From: Mark Simmons
Sent: 06 October 2025 16:09
To: Tom Rea
Subject: FW: Tussocks, The Causeway, Therfield, Royston, Hertfordshire, SG8 9PP - 3no. DOC's in connection with planning application ref: 24/01371/FP

25/02141/DOC - Details of Condition : Details reserved by Condition 5 (Roof materials) of planning permission reference 24/01371/FP granted on 19.02.2025.

25/02239/DOC - Details of Condition : Details reserved by Condition 6 (External bricks) of planning permission reference 24/01371/FP granted on 19.02.2025.

25/02240/DOC - Details of Condition : Details reserved by Condition 7 (Windows Details) of planning permission reference 24/01371/FP granted on 19.02.2025.

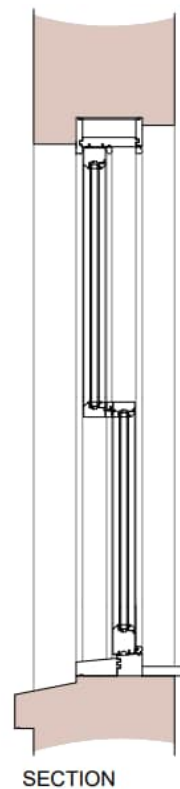
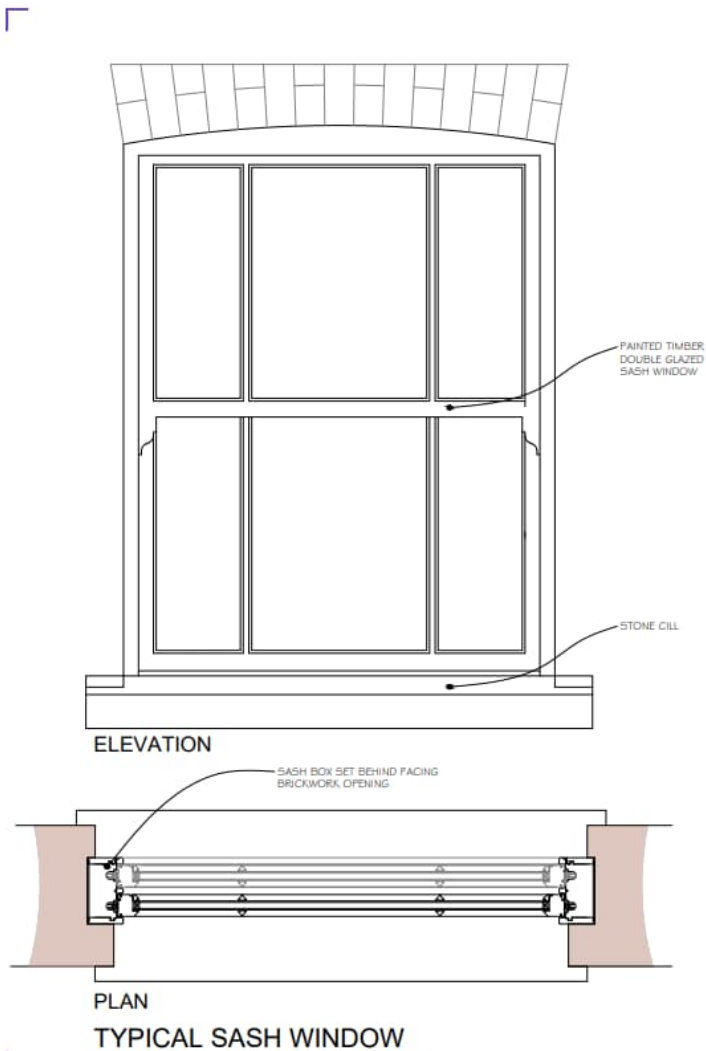
The Masaya brick from the Caprice factory (link below) is considered **ACCEPTABLE** in heritage terms for this project.

JOINERY DETAILS PART 2 OF 2		
HILLCREST & TUSSUCKS THE CAUSEWAY THERFIELD		
DATE:	DRAWN BY:	
18/01/20	11110	
478.60

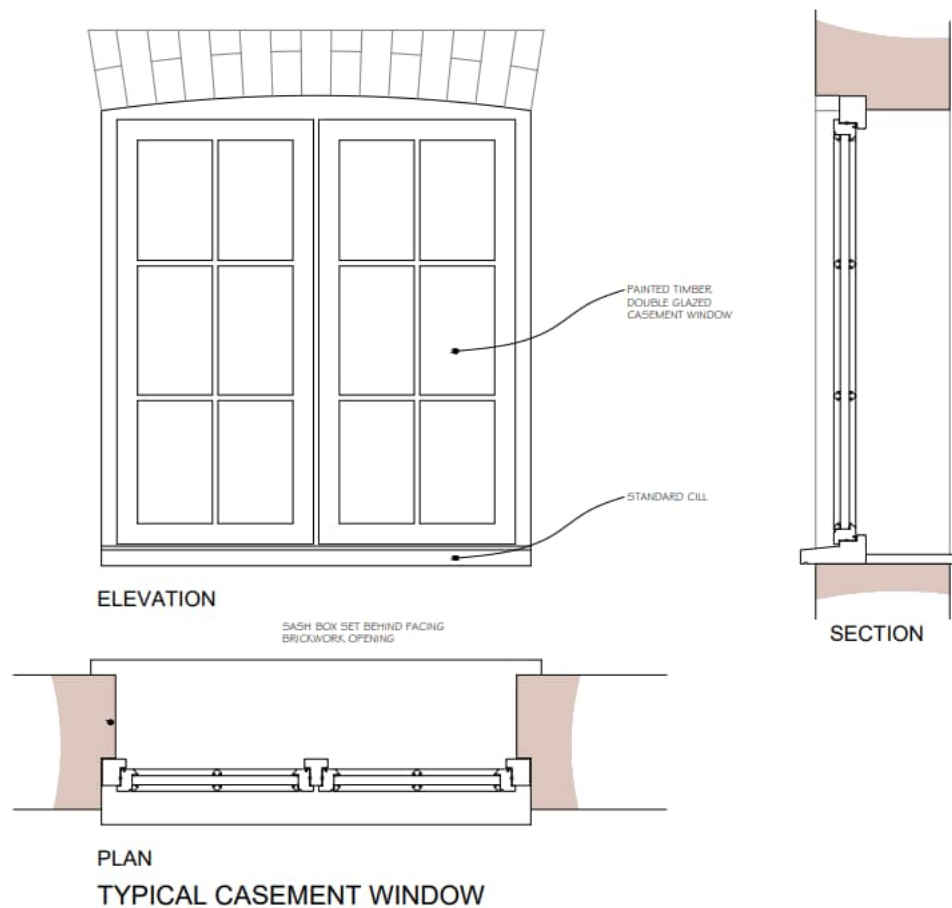
Although displaying applied/bonded glazing bars with similar profile internal and external rather than let's say ovolo (internal) and chamfered to mimic putty glazing (external) and not knowing the cavity width of the dgu's, these windows are for a new build scheme rather than listed building work and the significant issue here is that the vertical sliding sashes in particular are precisely that and not false 'sash-effect' windows. The details of typical sash window detail (drawing ref 478.59 from Kingston Studio) and typical casement window detail (drawing ref 478.60 from Kingston Studio) are considered **ACCEPTABLE** in heritage terms for this project.
